AEPSC Sinton – Beeville – Kenedy Load Area Improvements Project

Version 1.0

Figure II: Approximate Location of Upgrades

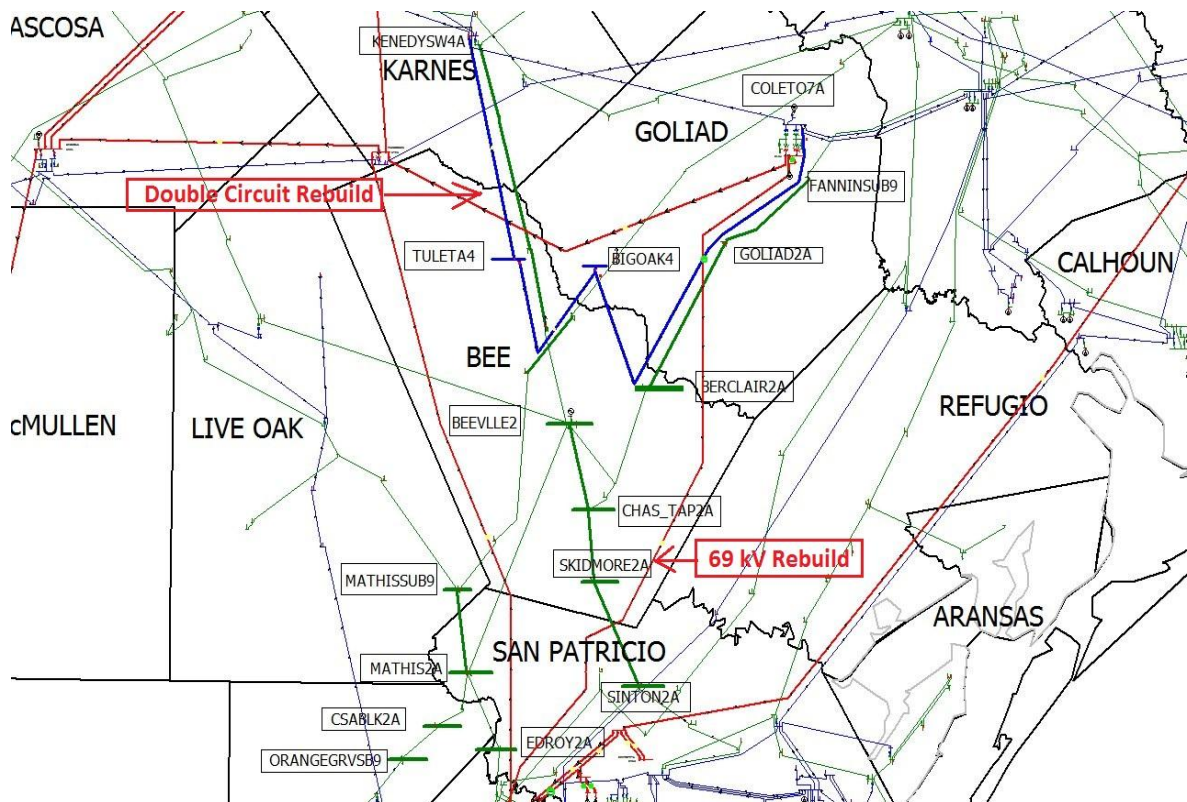
It should be noted that the upgrades listed in last two bullets under Option 1 are in addition to what AEPSC proposed initially in order to serve the load reliably. The total cost estimate is approximately \$93.15 million for these improvements.

The n-1 (AC contingency) analysis showed no overloads with option 1. Full AC Contingency results are provided in the Appendix B.

It should be noted that the upgrades discussed in Option 2 are similar to the upgrades discussed in Option 1 except the installation of phase shifting transformer (PST) at Sinton has been omitted.

It should be noted that the upgrades discussed in Option 3 are similar to the upgrades discussed in Option 2 except that the Edroy – Smith – Mathis 69 kV line was upgraded instead of installing a 15 Ohm series reactor at Edroy.

All three options studied resolved the identified reliability issues. Based on the cost estimates, Option 2 was preferred over Options 1 and 3. Upgrades discussed under Option 2 were studied for additional sensitivities.

Based on the reliability analysis it was determined that the following transmission upgrades studied as Option 2 would constitute the most effective and least cost solution to serve the projected load addition:
